## DRB MEETING

**PRELIMINARY PLAT REVIEW  
Seven (7) Lot Major PUD Subdivision  
PR-002-24**

Sandy Birch Road LLC, hereafter referred to as Applicant, is requesting Preliminary Plat review for a seven (7) lot major PUD subdivision. The parcel is located on Sandy Birch Road between Sandy Lane and 1085 Sandy Birch Road, Georgia, Vermont. The parcel is ±34 acres and is entirely located within the AR-3 Zoning district.

PHASE II - OVERALL SITE PLAN

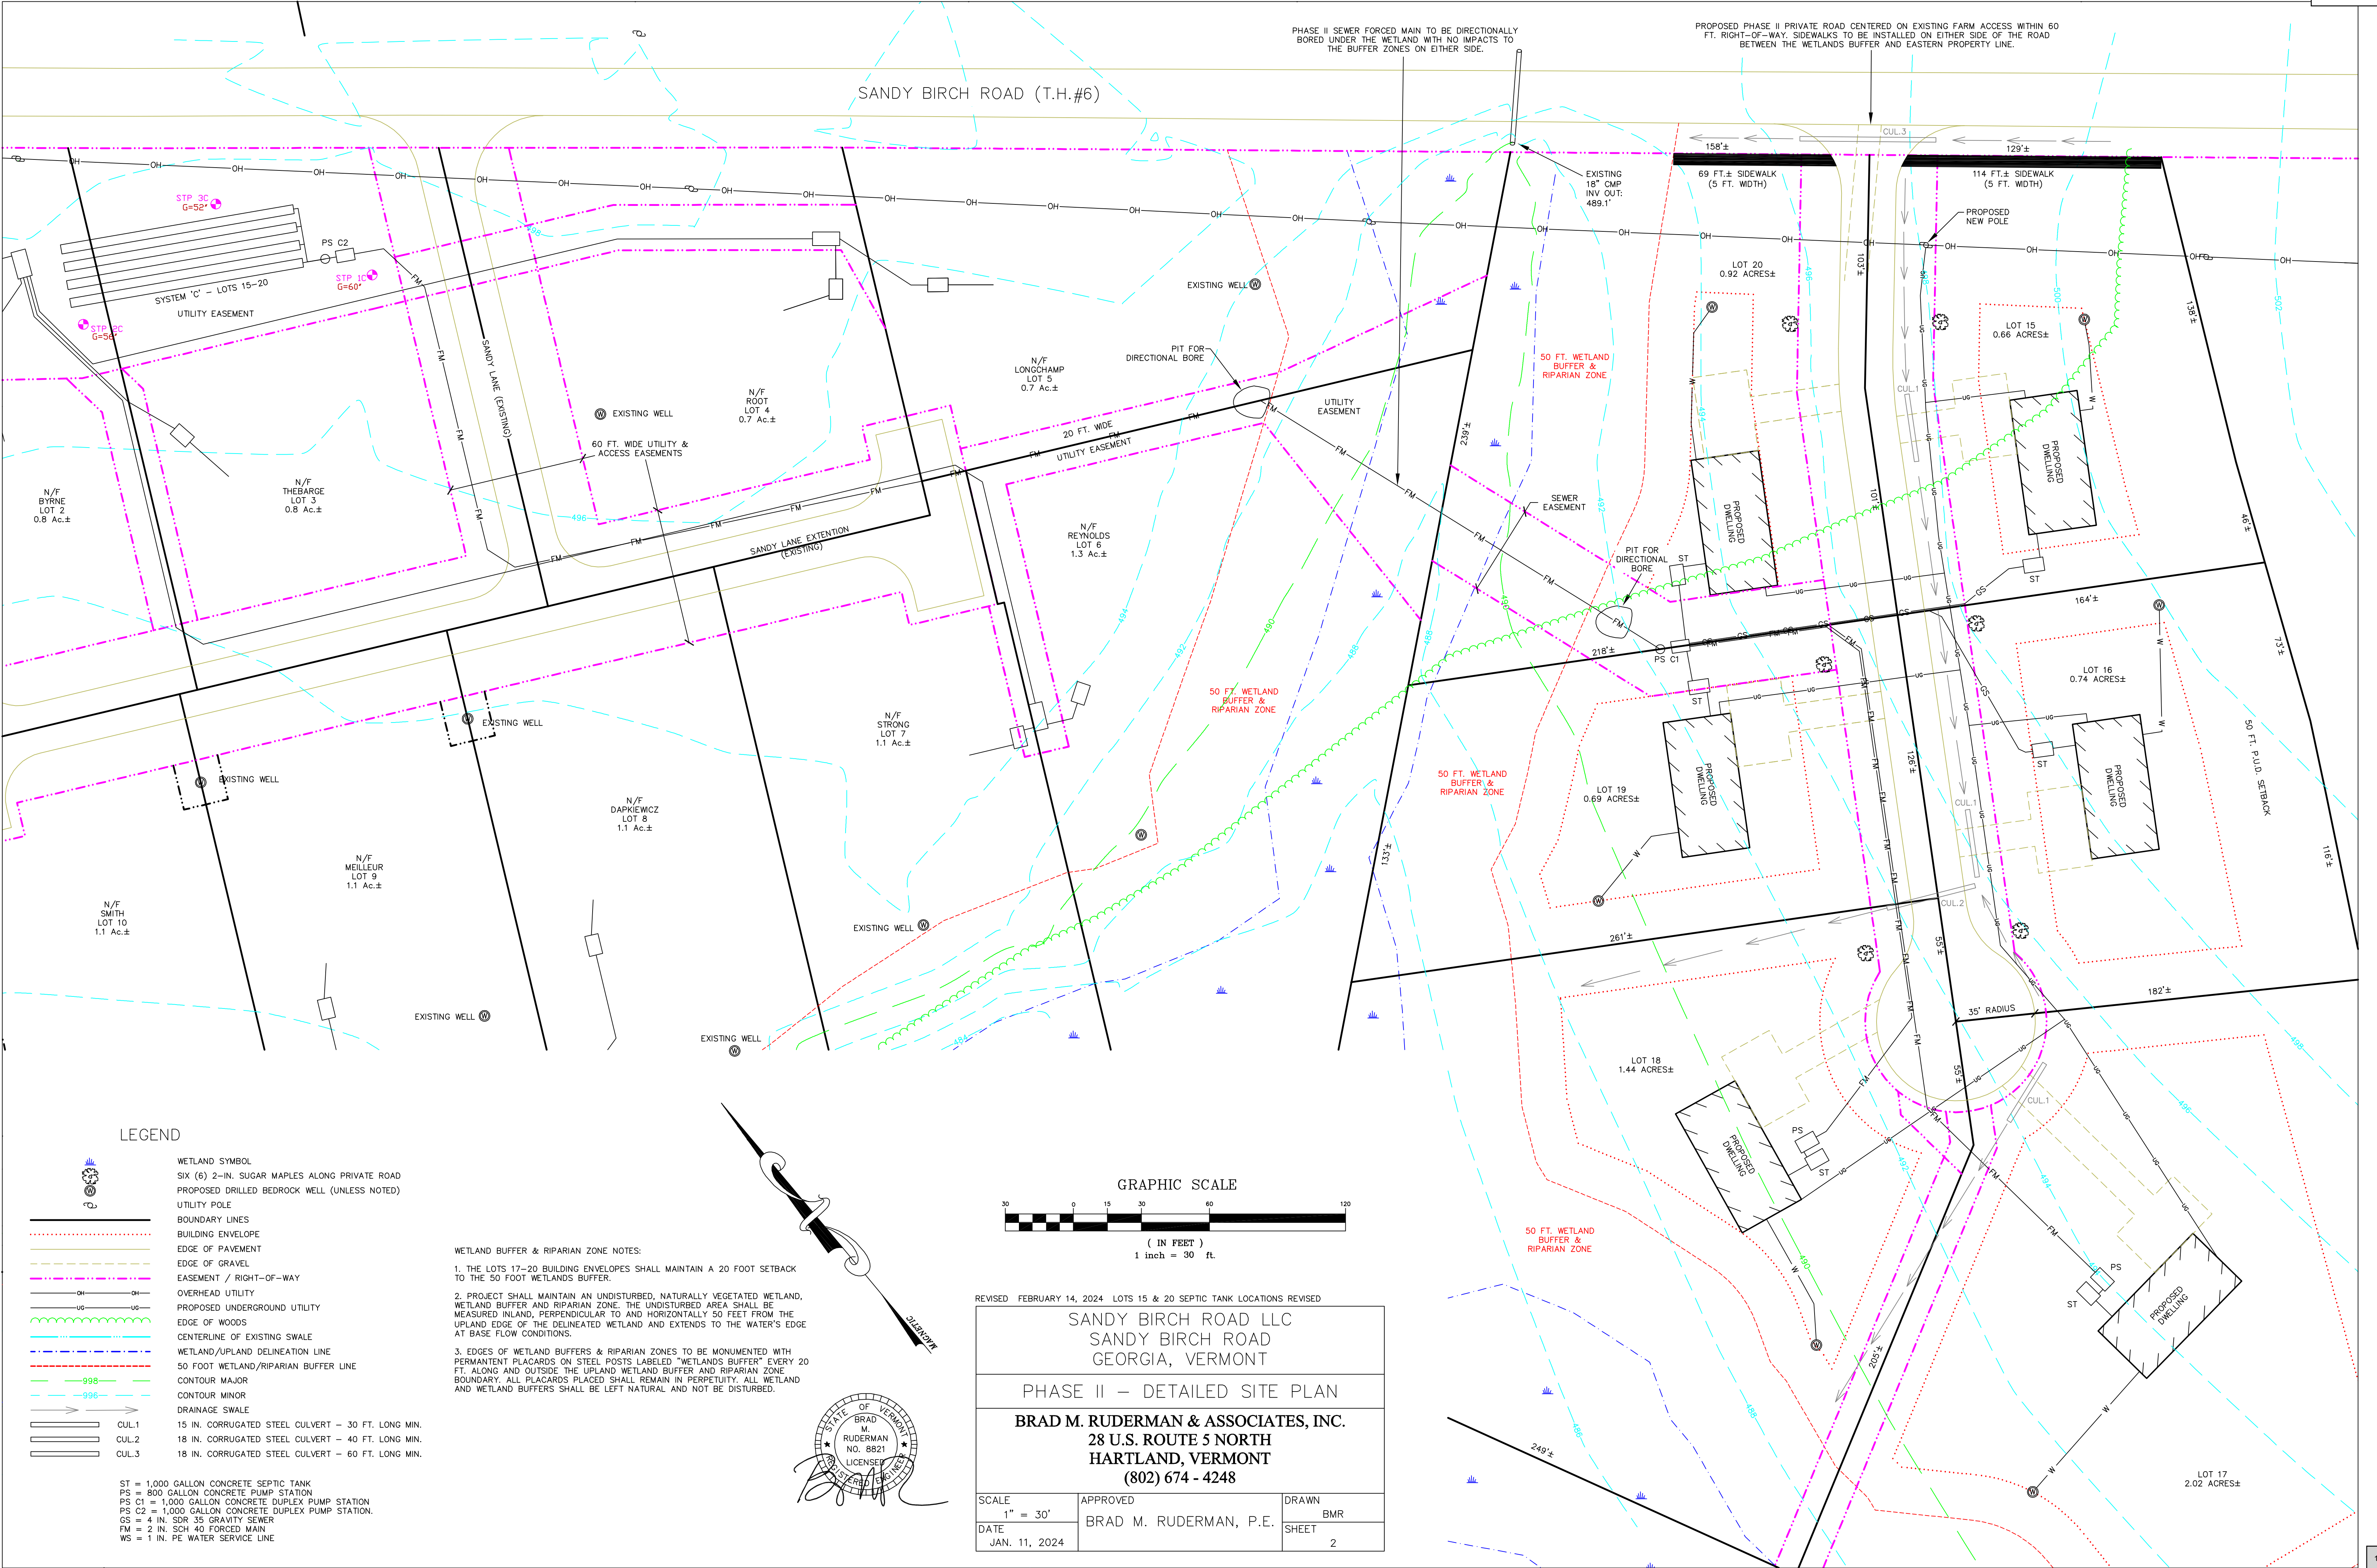
3. **Site plans.** Applicant has submitted the following site plans prepared Brad M. Ruderman & Associates, Inc. and titled:

- 1. “Sandy Birch Road LLC- Phase II Overall Site Plan” dated 1/11/2024.
- 2. “Sandy Birch Road LLC- Phase II Detailed Site Plan” dated 1/11/2024.
- 3. “Sandy Birch Road LLC- Road, Stormwater & Erosion Control Details” dated 1/11/2024.
- 4. “Sandy Birch Road LLC- Phase II Survey Sheet 1” dated 3/14/2024.
- 5. “Sandy Birch Road LLC- Phase II Survey Sheet 2” dated 3/14/2024.

4. **Lot layout.** As proposed, the boundary lines are linear and proposed lots are generally regular in shape.

**Section 7.7 Vehicular Circulation** – Lots will be accessed by use of proposed private road with cul-de-sac.

**PHASE II - DETAILED SITE PLAN**

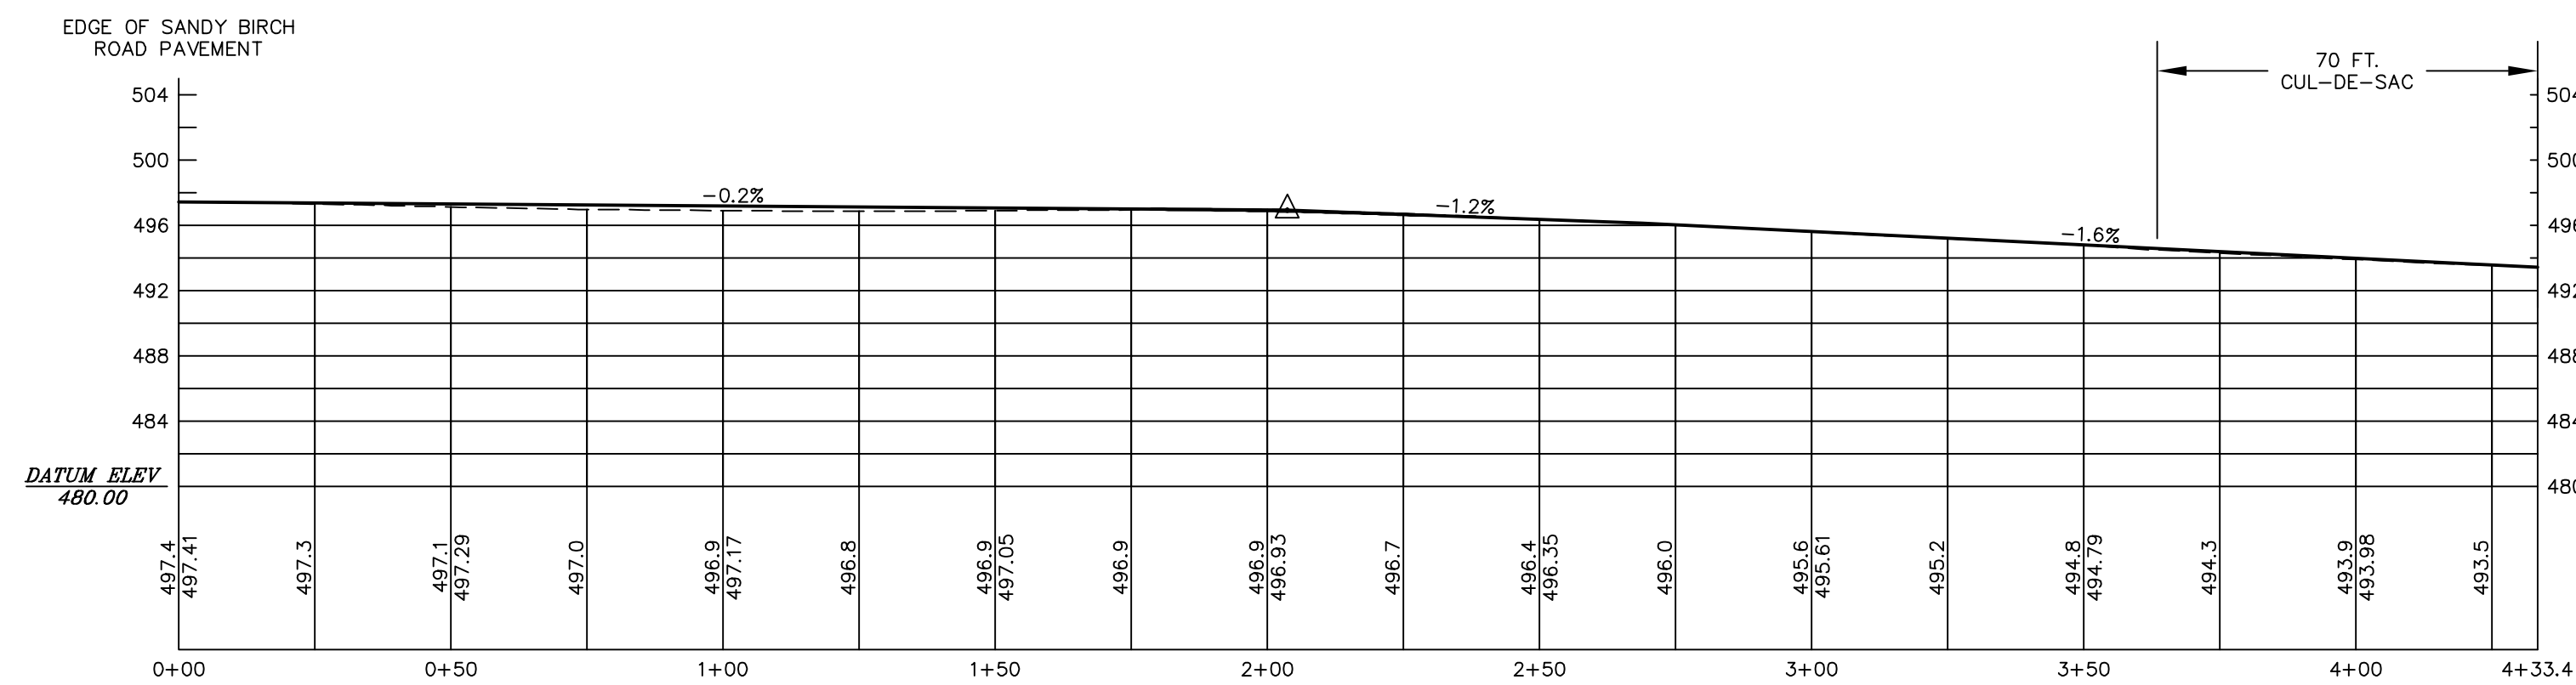
10. **Pedestrian Traffic.** See waiver information for pedestrian accessibility on proposed private road. Regarding the sidewalk along Sandy Birch Road, the DRB agreed in Sketch that the sidewalk will be “dead-ended” at the edge of the wetland buffer, similar to Phase I. Connecting the two sidewalks from Phase I and Phase II would require a state of Vermont Wetlands Permit to fill and work within the wetland and buffer zones that separate the two subdivisions. This project has avoided all impacts to wetlands and buffer zones to date without the need to go through the state permit process.

13. **Vehicular Traffic.** Lot 14 is currently accessed via a farm drive off Sandy Birch Road. The farm drive will be upgraded to private road standards. All proposed lots will be accessed via the new shared private road; each lot will have an individual driveway with a minimum of two parking spots available in front of the dwellings.
